# NO $\nu$ A Far Detector Networking Review Report

**Feb. 14<sup>th</sup>, 2013  
version 1.0**

The NO $\nu$ A deputy project manager requested a review of the networking for the NO $\nu$ A far detector. The Scientific Computing Division, SCD, NO $\nu$ A liaison convened a review in January 2013. The committee reviewed and discussed requirements, design, implementation, support, documentation, procedures and evolution of the NO $\nu$ A far detector networking over a several weeks period. The observations of the committee are documented in this report.

Figure 1: Current network topology at the far detector.

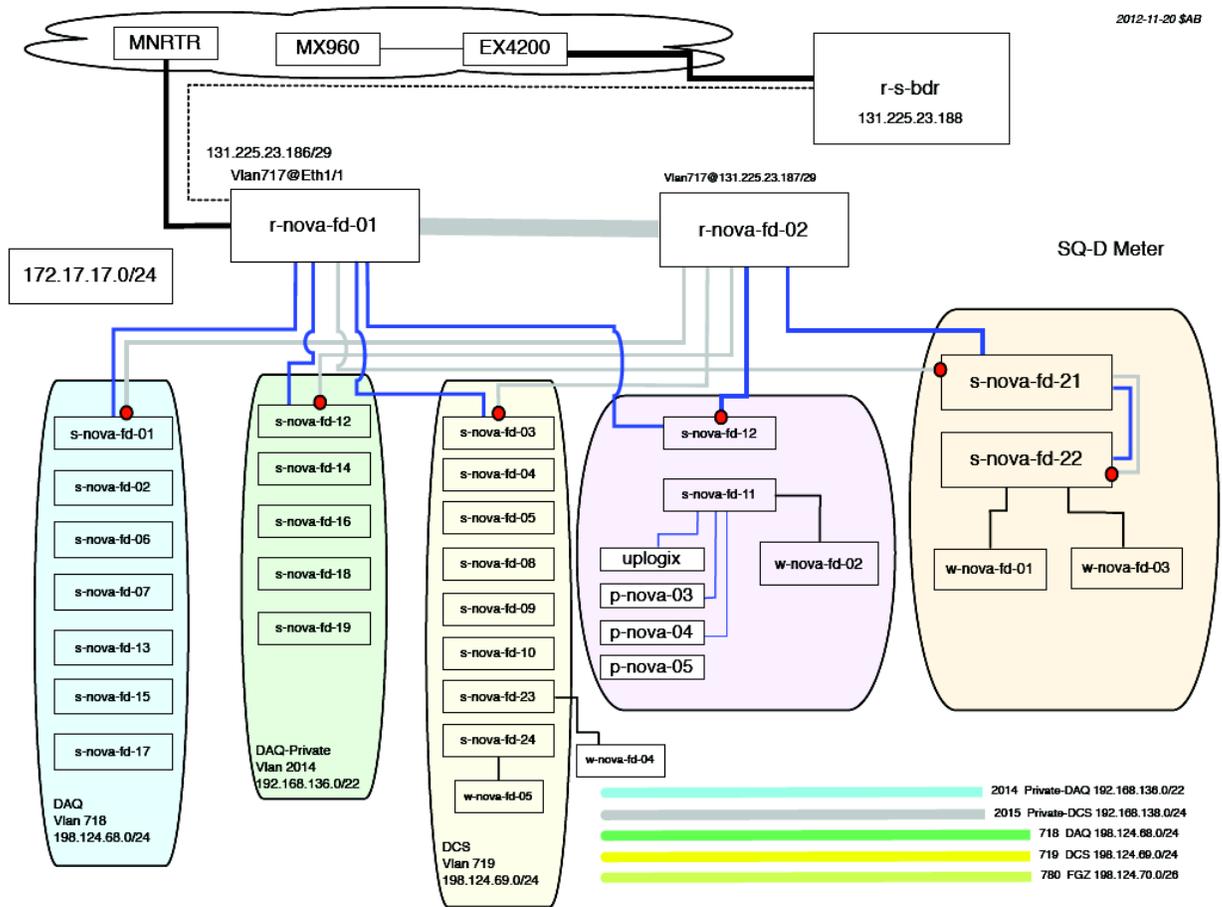
The committee believes that the design and implementation of the IP network at the far detector meet the documented requirements listed above. The current WAN bandwidth exceeds the required bandwidth even in the case of lower signal thresholds. Available network ports and LAN bandwidth meet the requirements above. The Cisco Nexus 5548 are switches/routers that provides 960 GBit/sec throughput<sup>2</sup>. Both DCMs and PC farm nodes are connected to Cisco 4948 switches with 10 GBit/sec uplinks. The number of concentrator switches could be doubled if additional bandwidth or ports are needed.

- **There is no uptime requirement for the network.** Although the pair of Nexus 5548 provides redundancy at the core, failure of a concentrator switch will cause outages of DCMs, buffer nodes and/or control systems. Due to the remote location repairs of the network may take hours or days.
